RE: ADDITIONAL INFORMATION REQUESTED FOR THE MOORE RANCH IN
SITU URANIUM RECOVERY PROJECT LICENSE APPLICATION (TAC
JU011), SAFETY EVALUATION REPORT OPEN ISSUES.

**MOORE RANCH URANIUM
PROJECT**

SAFETY EVALUATION REPORT

OPEN ISSUES

FIGURE 1.8-1 Moore Ranch Project Production, Restoration and Decommissioning Schedule

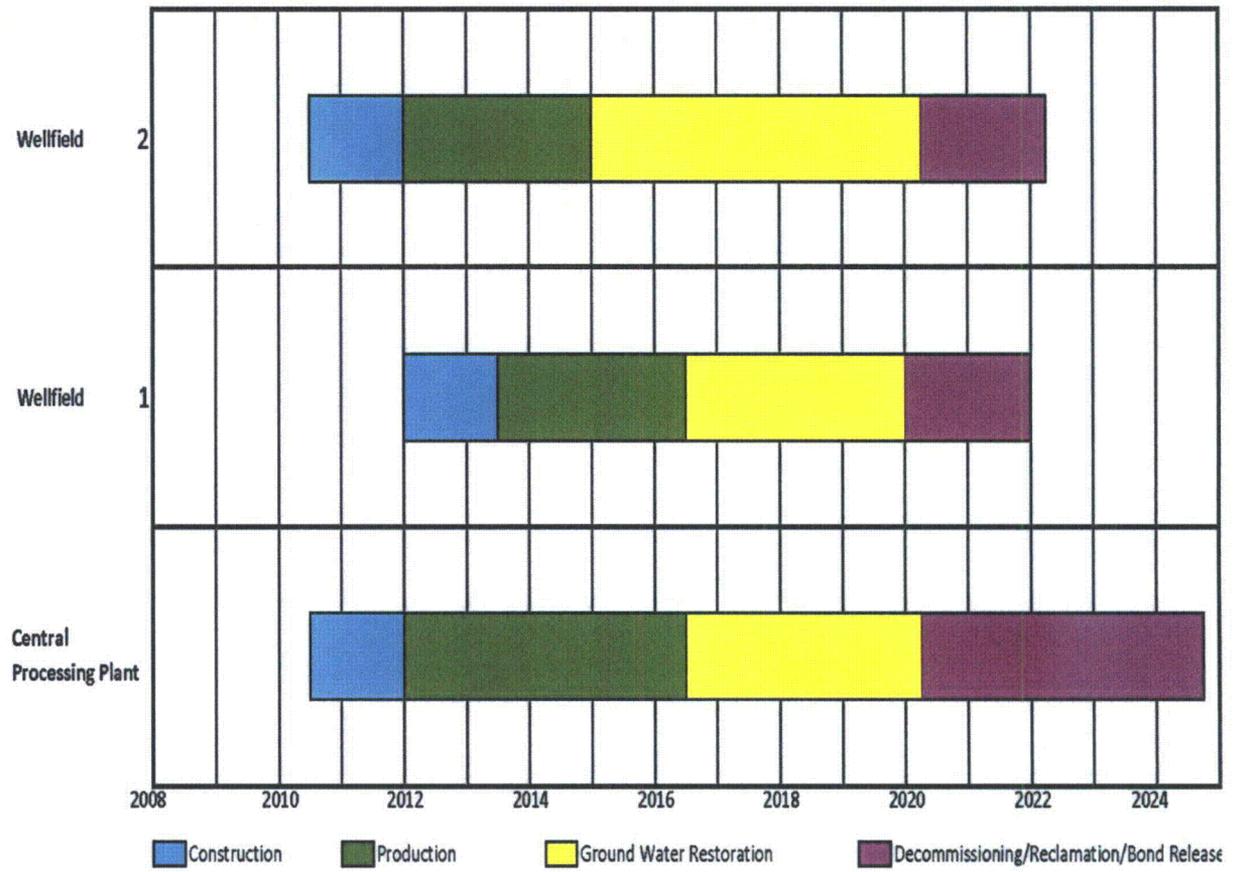
The schedule of activities shown in figure 1.8-1 of the TR indicates construction is to begin in early 2009 with production starting in mid 2009. This should be updated and consistent in the TR.

Figures 1.8-1, 3.1-6 and 6.1-1 have been revised to reflect the current schedule of activities and will be inserted in the revised Technical Report.

Figure 1.8-2 revised to reflect 2 wellfields as shown in Figure 1.8-1 Moore Ranch Production, Restoration and Decommissioning Schedule.

Figure Number:
5.7-1

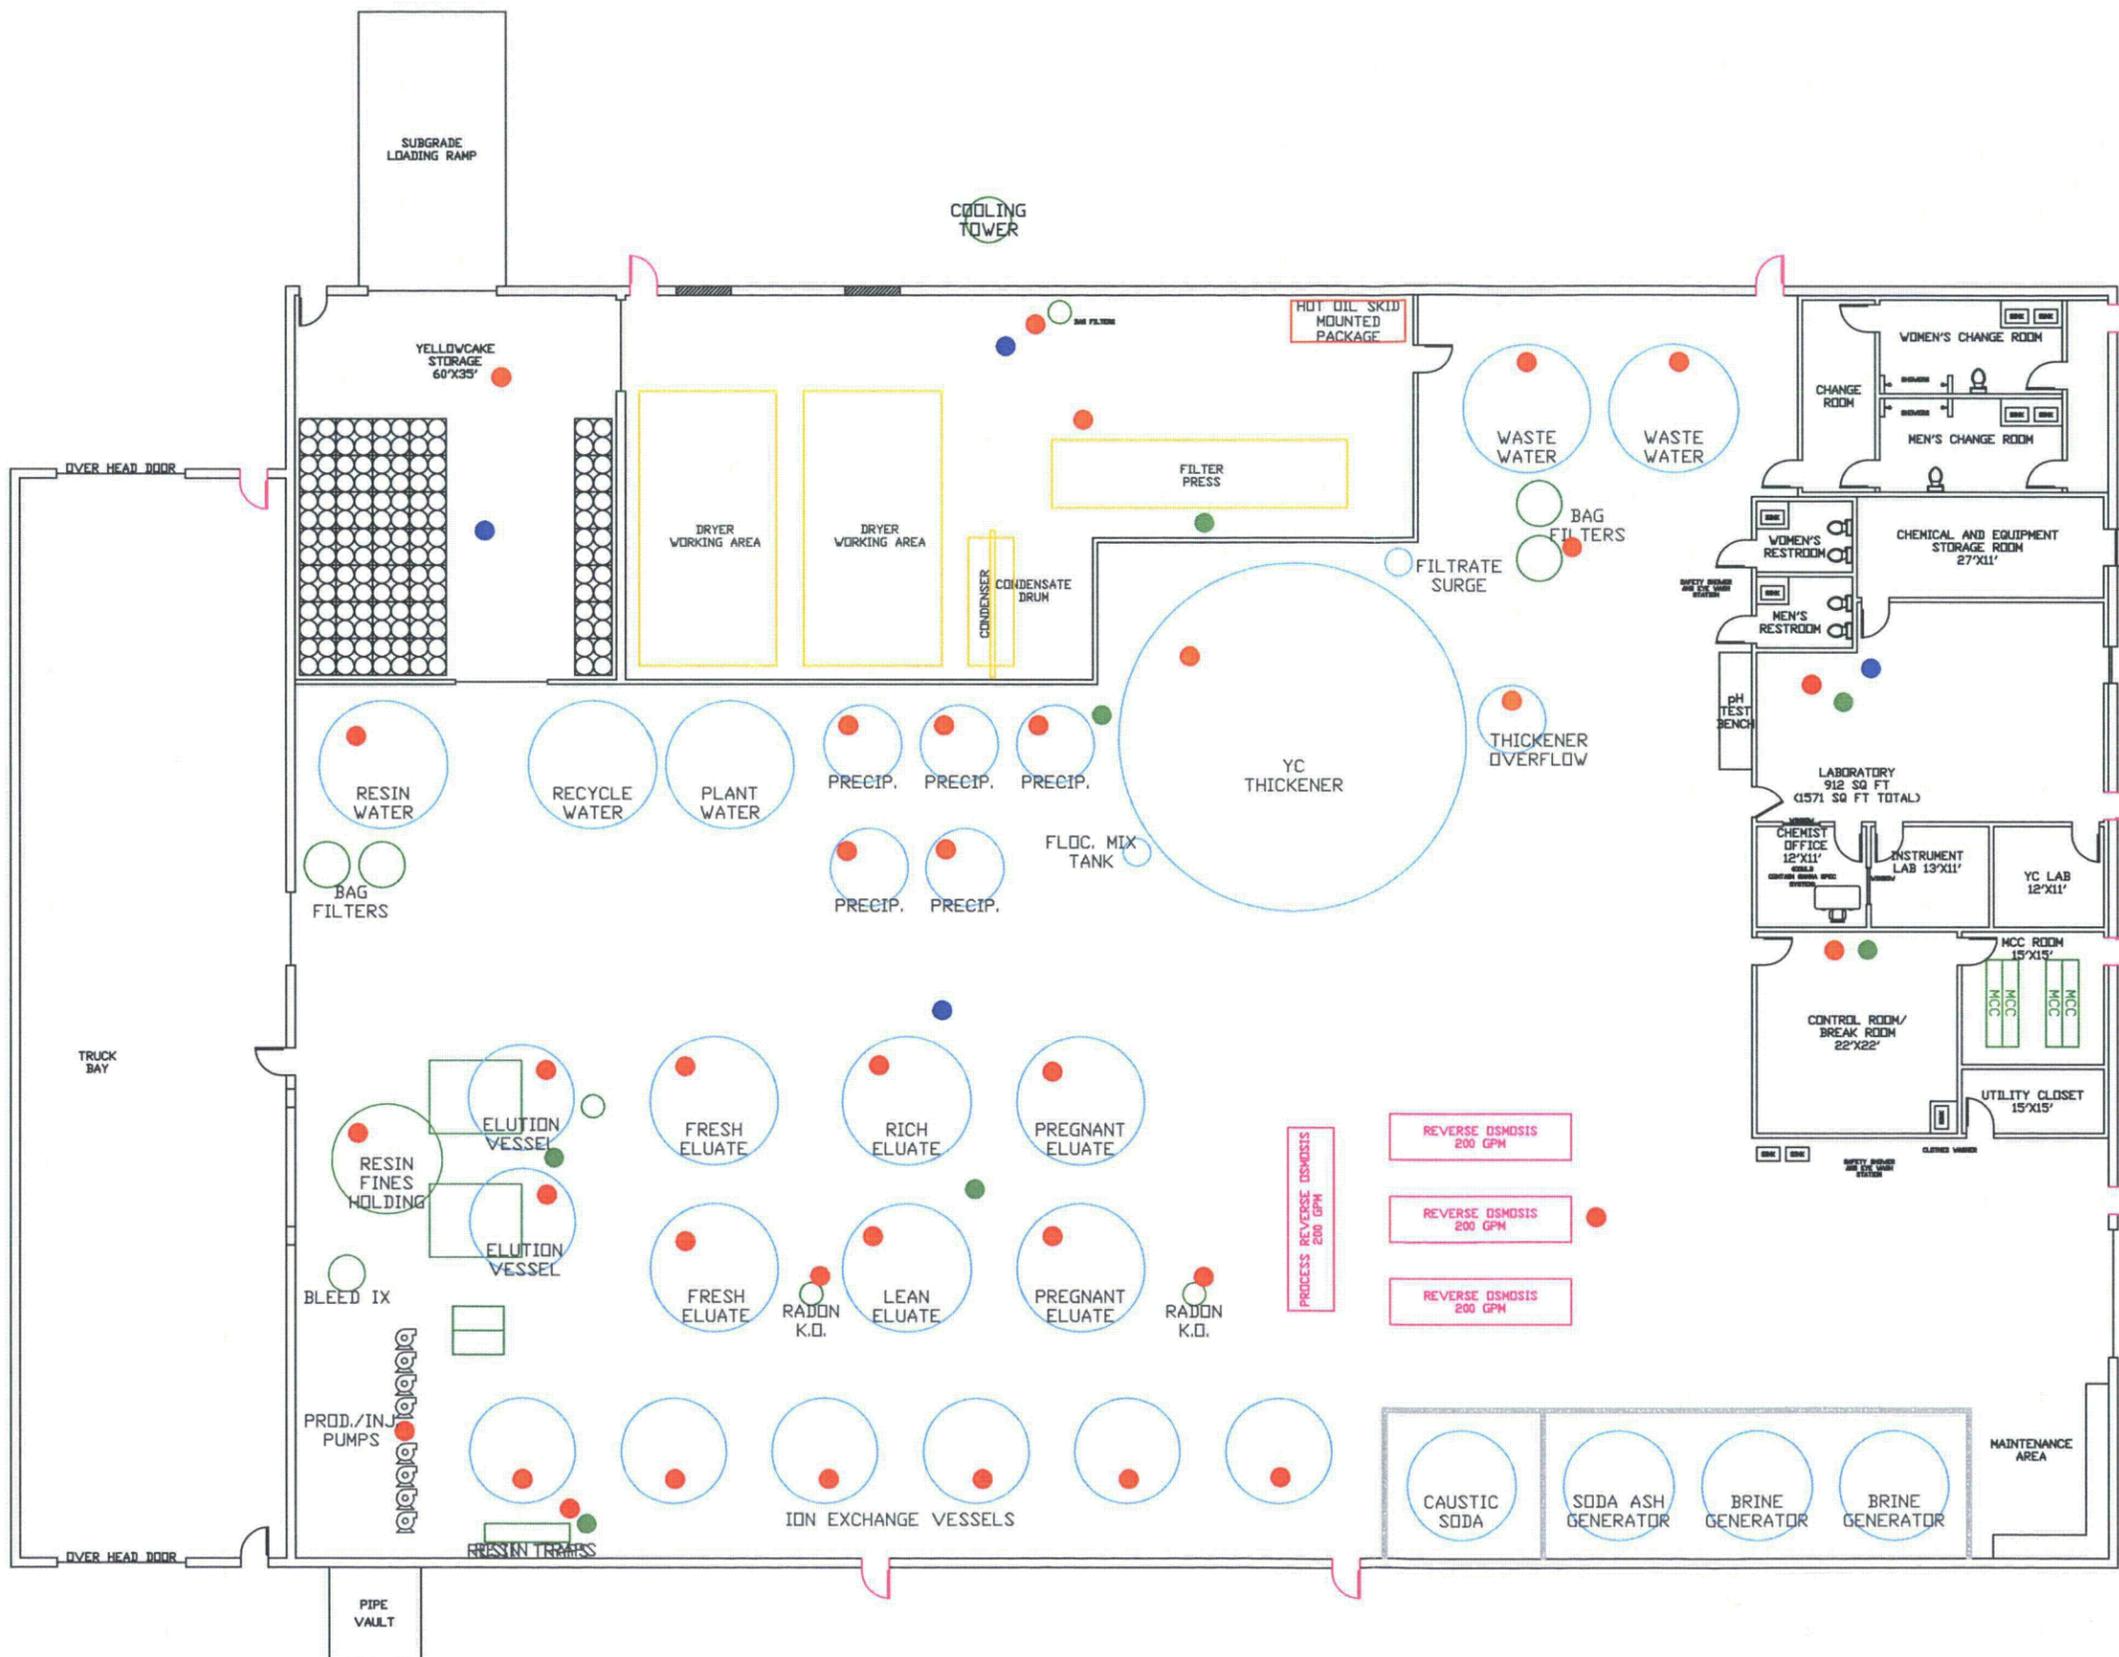
EMC indicated in Section 3.2.3.2 of the TR that a description of the areas in the proposed plant facility where radiological gases or air particulates could be generated is provided in Section 5.7 and shown on Figure 5.7-1 as monitoring locations. Note that Figure 5.7-1, intended to show monitoring locations for potential radiological gases or air particulates, is missing.

Revised Figure 5.7-1 has been provided.

Figure 6.1-1

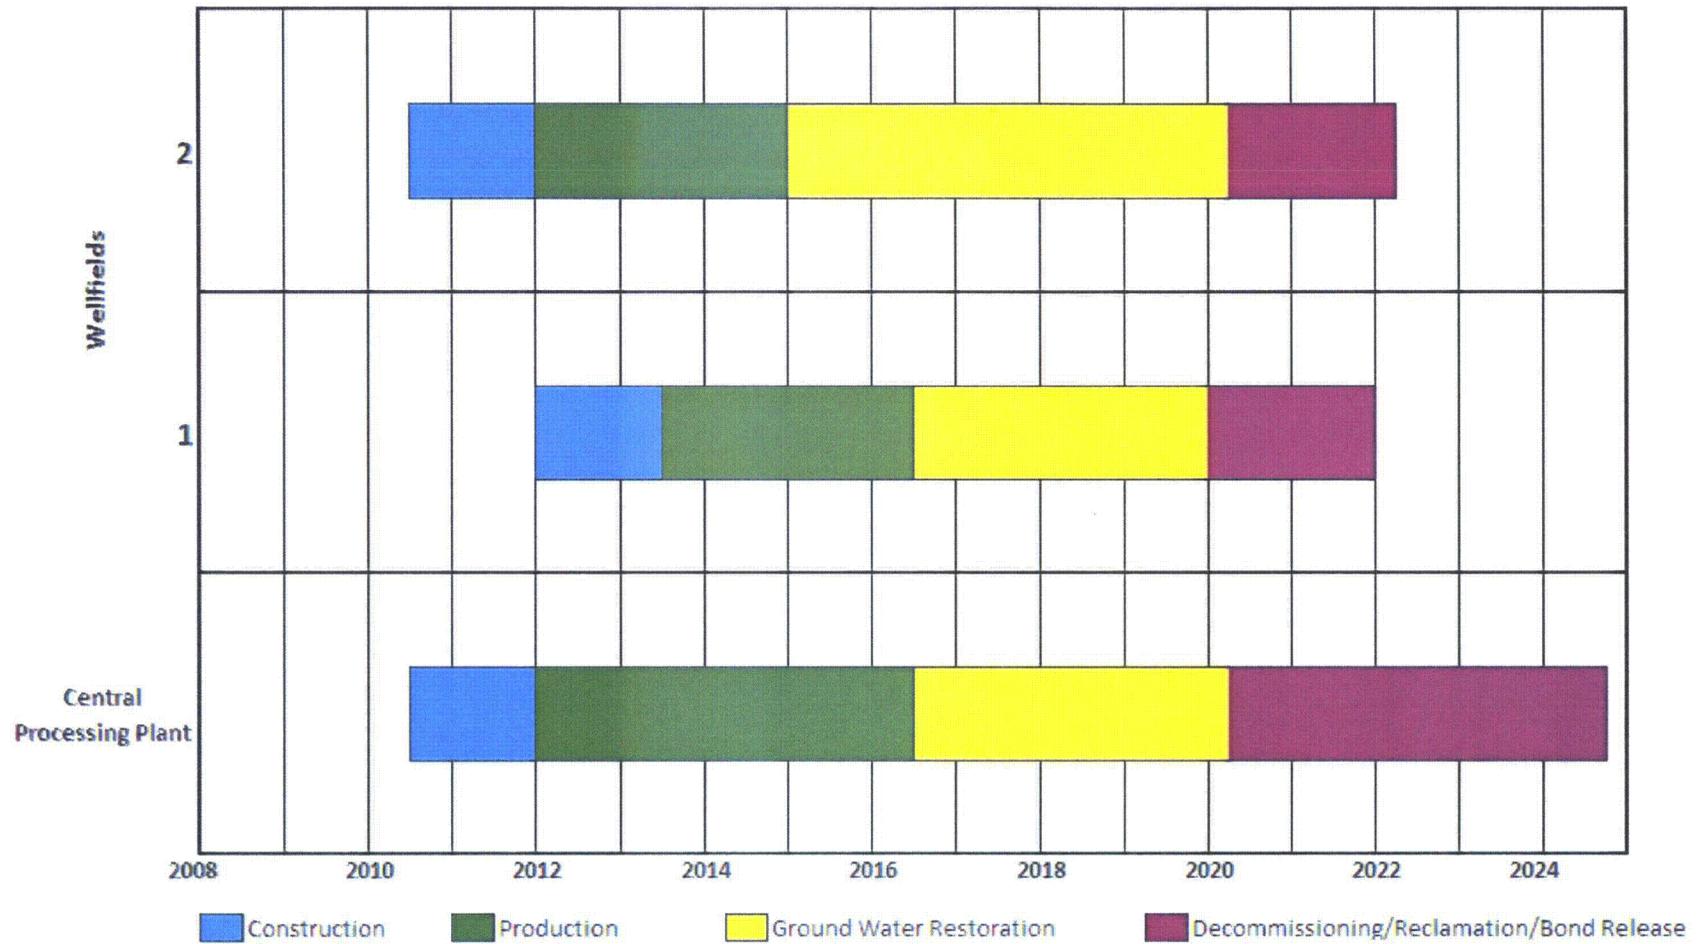
A preliminary wellfield restoration schedule was provided in Figure 6.1-1 of the Technical Report. EMC reported that based on the results of the numerical groundwater flow modeling, it will take approximately four years to restore Wellfield 1 and six years to restore Wellfield 2. This restoration schedule conflicts with Figure 1.8-1 of the Technical Report.

Figure 6.1-1 has been revised and is consistent with Figures 1.8-1 and 3.1-6.

Text in Section 6.1.4 Restoration Schedule revised to reflect updated Figure 6.1-1
